YAMAHA MOTOR CORPORATION, U.S.A.

00V-076 (01)

RECALL

YZF-R1K, KC, L, LC; YZF-R6L, LC, M, MC FACTORY MODIFICATION CAMPAIGN

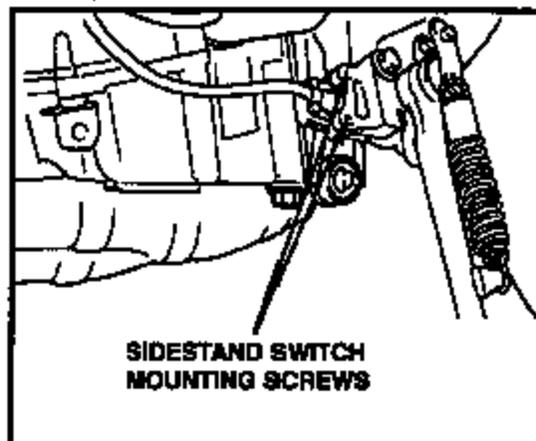
Yamaha Motor Corporation, U.S.A. has determined that a defect which relates to motor vehicle safety exists in 1998 and 1999 YZF-R1 motorcycles, and also in 1999 and certain 2000 YZF-R6 motorcycles. The screws holding the sidestand switch may loosen and fall out due to engine heat and vibration. If this happens, the sidestand switch would not function correctly, so it would be possible to ride the motorcycle with the sidestand in the down position. This condition would increase the risk that the sidestand could hit the ground during a turn, which could cause loss of control and an accident/crash with resulting personal injury or death.

To correct this defect, Yamaha is initiating a Factory Modification Campaign. Affected units must have the screws holding the sidestand switch replaced with a combination of bolts and nuts which will hold the switch securely. Due to changes in the way fuel-tank overflow and breather hoses are routed on late-production YZF-R1 units, there are two different Bolt Kits. Order the correct Bolt Kit for the unit being modified as described in this bulletin.

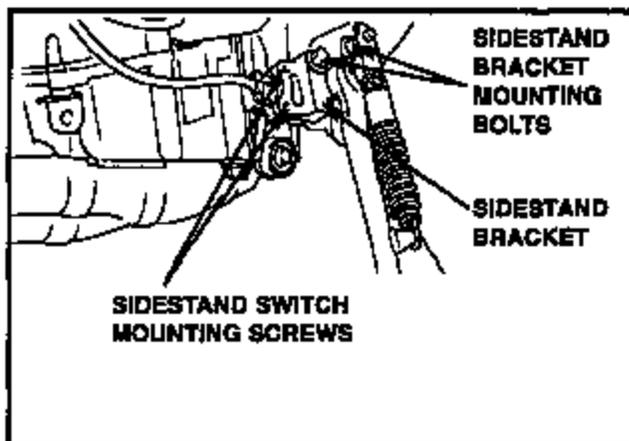
There was a mid-production change on 1999 YZF-R1 because a clamp was added to hold the fuel tank overflow hose and breather hose. The following motorcycles must be modified with Bolt Kit "B" which has longer bolts to accommodate the clamp on the switch:

All other affected YZF-R1 units as well as all affected YZF-R6 units use Bolt Kit "A."

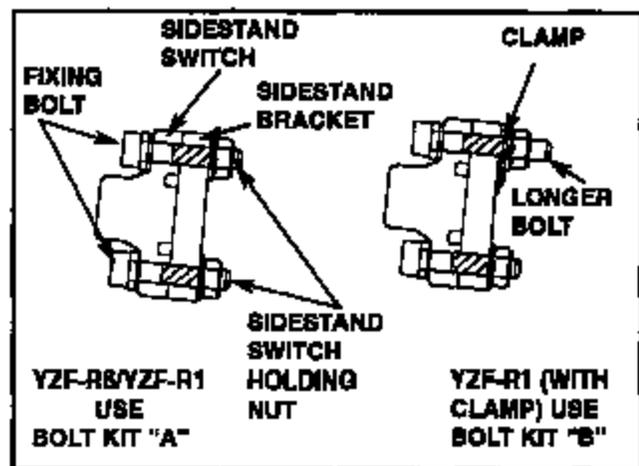
4. Assemble the sidestand switch again on sidestand bracket by installing the 2 new sidestand switch holding bolts from the kit.

Tightening Torque: 3.8 Nm (0.38 m-kG, 2.7 ft-lb.)

Bolt Kit "B" is for YZF-R1 units with the clamp for hoses. Use the longer bolt in the top mounting hole where the clamp is located.
